Agenda Item # 1 - HOLDOVER

SUB-002996-2024 & SUB-SW-002972-2024

Anglebrook Subdivision

APPLICATION NUMBER <u> 1 </u> DATE <u>September 19, 2024</u>	 NTS
APPLICANT <u> Anglebrook Subdivision</u>	
REQUEST <u> Subdivision, Sidewalk Waiver</u>

DETAIL SITE PLAN

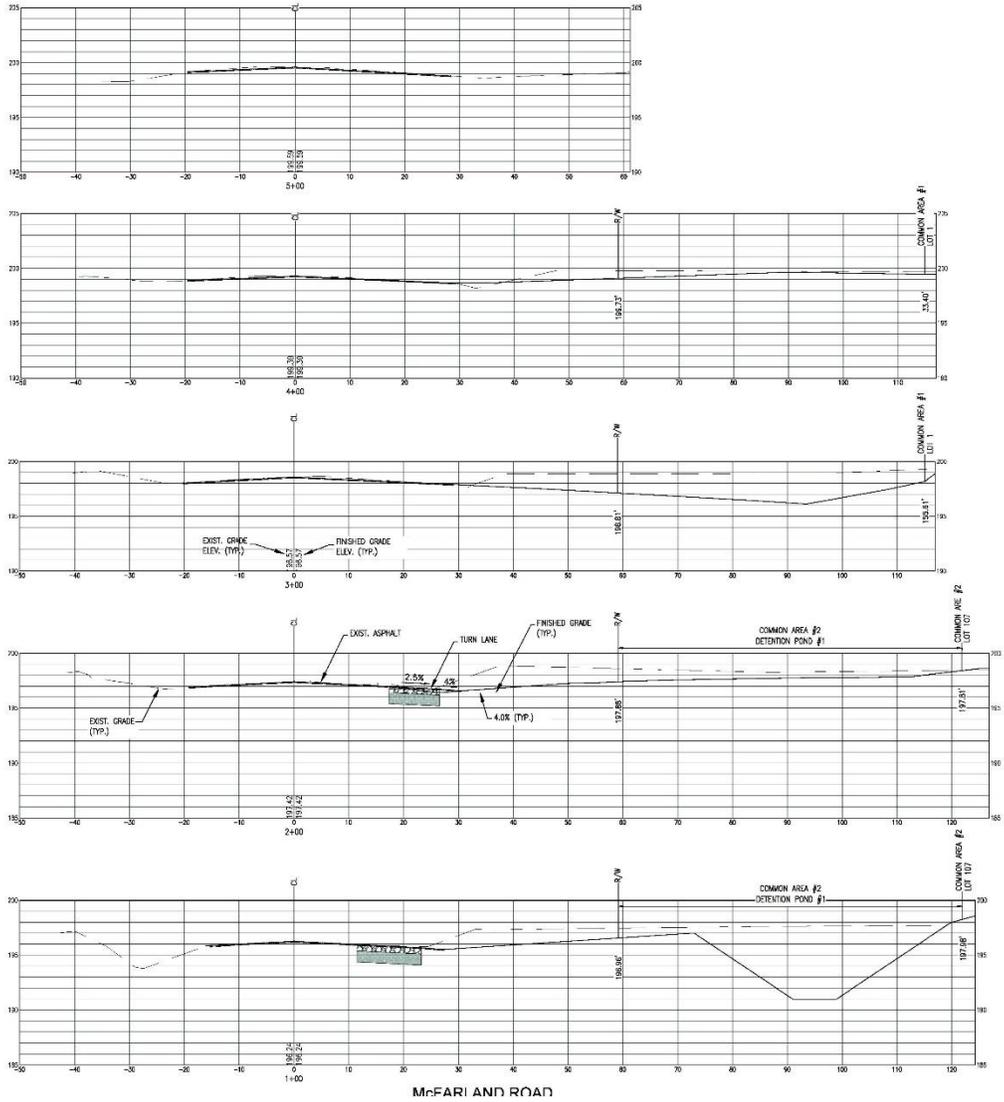
- D. Label every proposed drainage easement as "PRIVATE"; except that the drainage easement between LOT 76, 77, 90, and 91 shall be labeled as "PUBLIC".

All lots and Common Areas are dimensioned on the preliminary plat and labeled with their areas in both square feet and acres. All proposed lots meet the minimum size requirements of Section 6.C.2(b)(2) of the Subdivision Regulations for residential lots located within an area designated as Suburban in the Unified Development Code. The lot dimensions should be retained on the Final Plat, if approved, as well as the lot size labels, or a table should be furnished on the Final Plat providing the lot sizes in both square feet and acres. Proposed Lots 22, 23, 24, 46 and 47 would exceed the depth-to width ratio of Section 6.C.3. of the Subdivision Regulations and would require a waiver of that section, if approved. No lot number label was provided on Lot 77; therefore, the plat should be revised to label Lot 77.

It should be noted that proposed Lot 108 is intended to be a multi-family development within the proposed single-family subdivision. This concept was approved when the subdivision was originally reviewed and approved by the County Commission prior to annexation. As there is no zoning within the unincorporated areas of the County, this concept was allowable. However, now that the site is within the City of Mobile, Lot 108 cannot be developed for multi-family residential use until its area is rezoned to at least an R-3, Multi-Family Residential Suburban classification. The ZONING table on the preliminary plat should be revised to R-1, Single-Family Residential Suburban on the Final Plat, if approved.

One (1) of the proposed streets into the subdivision is indicated to be over 600 feet in length terminating in a cul-de-sac. Section 6.B.3. of the Subdivision Regulations states that closed-end streets shall not, ordinarily, be over 600 feet in length. Therefore, if approved, a waiver of Section 6.B.3. would be required. All proposed streets are

The preliminary plat indicates that sidewalks are to be provided along interior street frontages.
